TECHNICAL INFORMATION

A3411
February 2014

- Subject** ▶ Change of Armature
Addition of Flat washer 12
- For Models** ▶ BFS441, BFS451, DFS451, LXSf01, LXSf02, XSF01
- Country** ▶ All countries
- Description** ▶ Armature with Flat washer 5 has been replaced by Armature without Flat washer 5.
Flat washer 12 has been added.

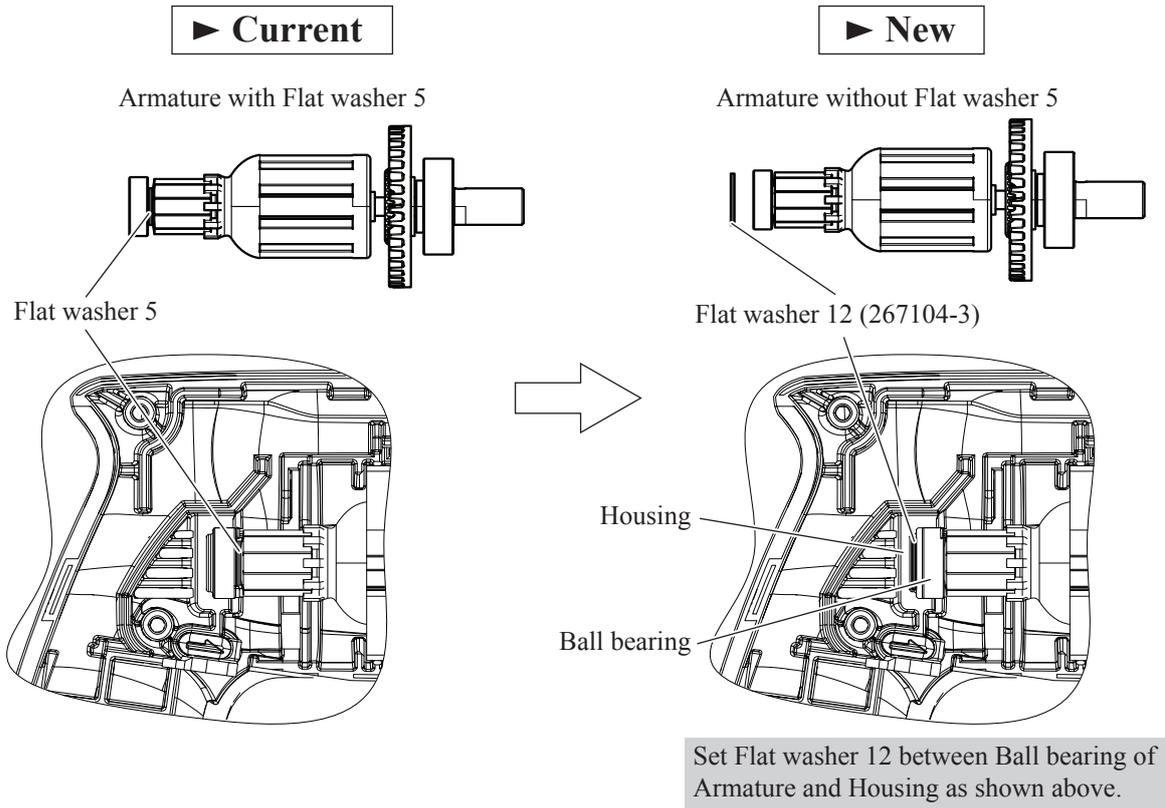
Item No.	Current part	Q'ty	I/C	New part	Q'ty	Note
028	Armature 619275-6	1	No	Armature 619350-8	1	BFS441, LXSf02 ↑ Interchangeable as a set
037				Flat washer 12 267104-3	1	
028	Armature 619277-2	1	No	Armature 619351-6	1	BFS451, DFS451, LXSf01, XSF01 ↑ Interchangeable as a set
037				Flat washer 12 267104-3	1

From March 2014 production
